Docket No. 50-346

May 3, 1982

This is in response to your letter dated March 8, 1982 (Log No. 918) concerning Masonry Wall Design; IE Bulletin 80-11, Request for Additional Information as it relates to Davis-Besse Nuclear Power Station Unit 1.

RESPONSE TO NRC QUESTIONS  
MASONRY WALL DESIGN

IDEALIZED SIMPLY-SUPPORTED UNIFORM BEAM

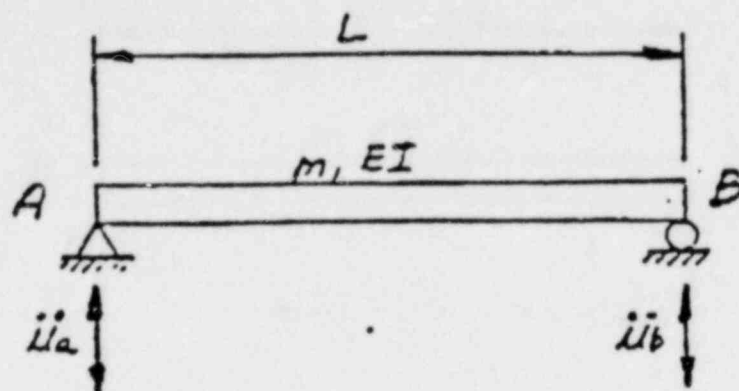
With reference to Section 7.1, Appendix E (2), use the envelope of the floor spectra or provide justification for using the average spectral acceleration.

The evaluations herein demonstrate that the use of the average floor acceleration response spectra to calculate the response of the wall panel is appropriate.

For the purposes of this evaluation, the seismic response of a simply-supported, uniform beam simulating a strip of the wall panel with unit width is considered, as shown in Figure 1:
